Proposed access points to Thanington Park:

1. A2 westbound slip road access Revised junction at A2 westbound slip road and A28

Here and below are sections of PPL's plan for the slip road copied from BDB Design's access diagram in PPL's **Design and Access Statement** dated October 2015.

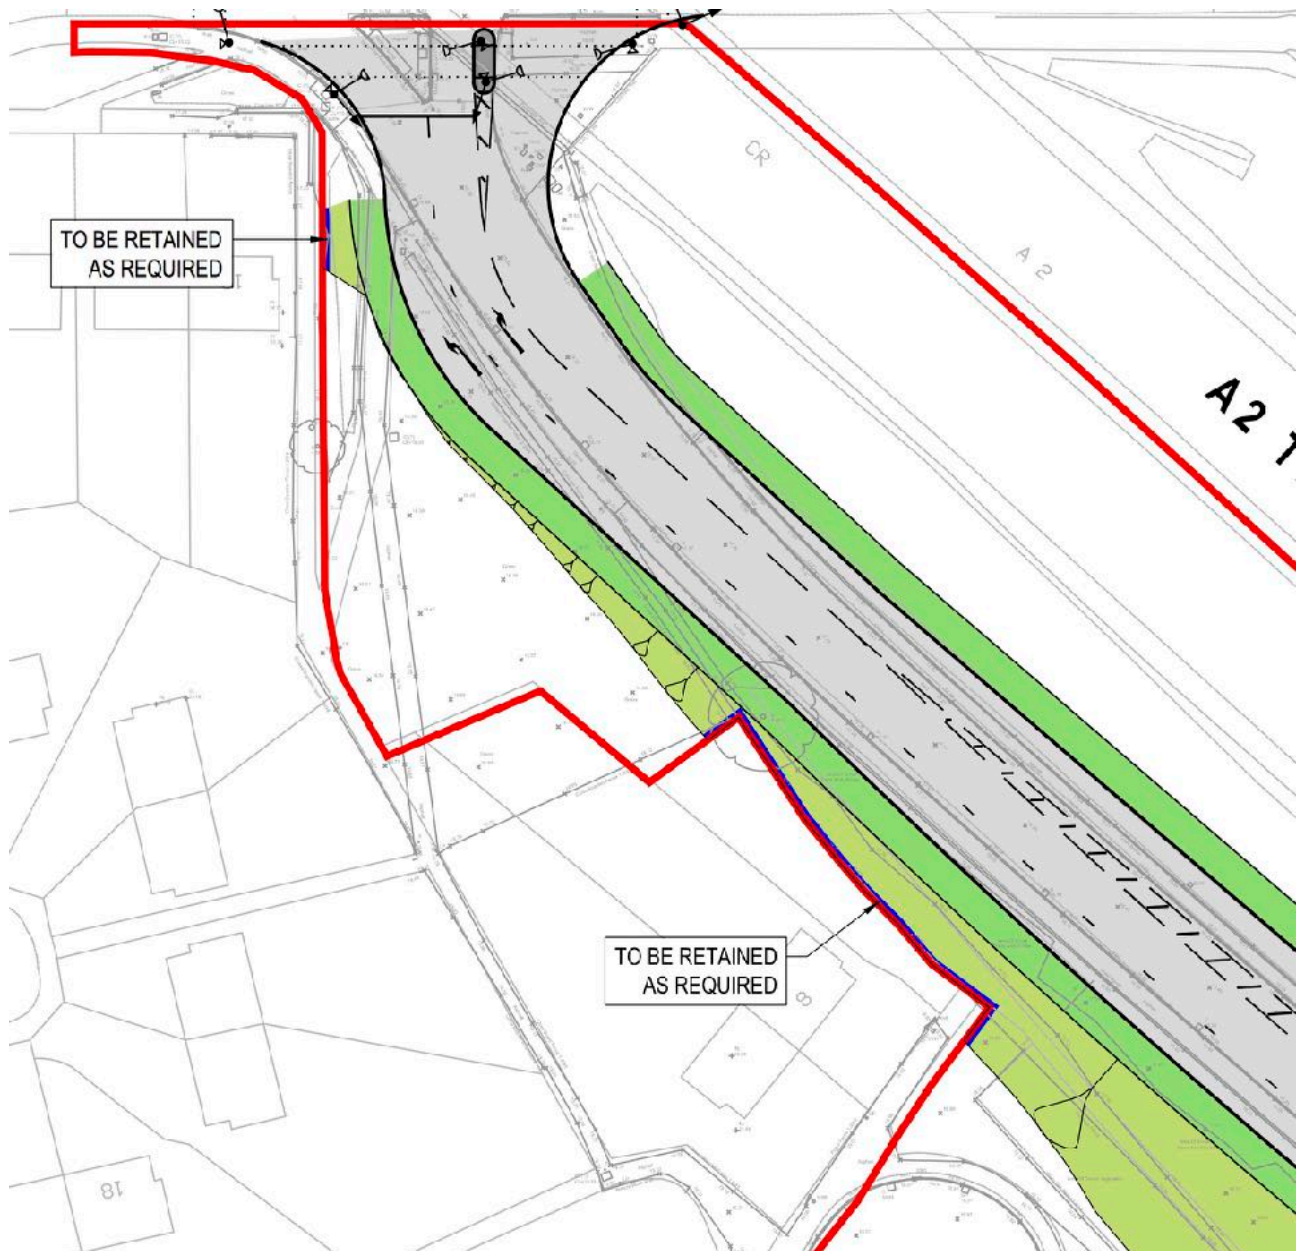
At the junction with the A28: “The revised radius of the eastern side of the junction bell mouth comes very close the parapet railing to the extent that at one corner the railing is too close to the edge of the carriageway and is likely to be prone to vehicle strikes. The other corner of the parapet restricts the footway width to the proposed crossing point to the extent that the layout is likely to be largely impracticable from a day to day usability perspective. We have reservations as to whether or not the correct clearance to the parapet can be obtained or practicable footway width past these pinch points”

Highways England continues: “Swept path analysis will be required to ensure that all vehicles likely to use this junction can do so safely without entering adjacent lanes. We have concerns that an HGV approaching the stop line northbound on the slip will to be able to make the left turn without encroaching into the adjacent lane and also the turn left onto the slip from Thanington Road looks dubious for large vehicles.”

Highways England continues: **Section of Two Way slip road:** The new opposing third lane runs close to the main northbound carriageway of the A2 Trunk Road particularly at the new junction on the slip road. It is likely that to construct this carriageway the embankment separating the slip road from the main alignment will need to be reinforced and proactive safety barrier will need to be provided along its full length. There may not be sufficient verge width to enable this to be achieved particular *{sic}* with regards to working width and set back. Furthermore, an environmental barrier will need to be provided to screen headlights of opposing flows of traffic between the slip road and main carriageway of the A2.

Is there room for a third contra lane down this slip road? Surely not, unless the exit lanes are shifted to the left over the pathway and a grassed area, and probably over the front garden of the first house to the west. Will demolition of that house be needed? Is there room for three HGVs in parallel anywhere on the altered slip road?

Is there room for a second pedestrian island at the junction mouth, between the northbound and southbound lanes? There is not, so how are pedestrians crossing the bridge over the A2 on the south side to do so safely?

What additional traffic lights will be required at this junction, and on what sort of sequence? Traffic currently travelling east and west on the A28 often is held up for several minutes, and through several light changes, while long lorries attempt to turn right from this slip road. The existing system is difficult for any driver not acquainted with it to negotiate.

The slip road approaches the A28 at a 45-degree angle. Long vehicles turning right though 135 degrees into the east-bound A28 have at least the full width of that road in which to manoeuvre. How will such vehicles turning sharp left into that angle do so without danger of breaching the parapet? The new very long HGVs are 7 foot longer than the current norm. (Also, negotiating 90 degrees mid-slip road will be difficult enough.)

Where will the “environmental barrier to screen headlights of opposing flows of traffic between the slip road and main carriageway of the A2” be located? The eastern side of the slip road is a 80/90 degree drop to the A2 at this point.

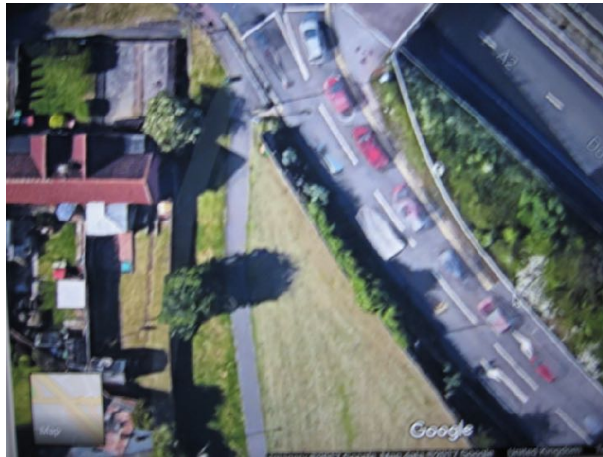
Half way up (or down) the slip road PPL proposes an access point to the development site. This is a startling proposal for an A2 exit road which is prone to long queues at most times of the day, not just rush hours. A viewing of Google Maps with the “traffic” facility enabled when the A2 is busy will show an amber, red or crimson line signifying a queue - usually reaching as far back, if not further, than the proposed junction.
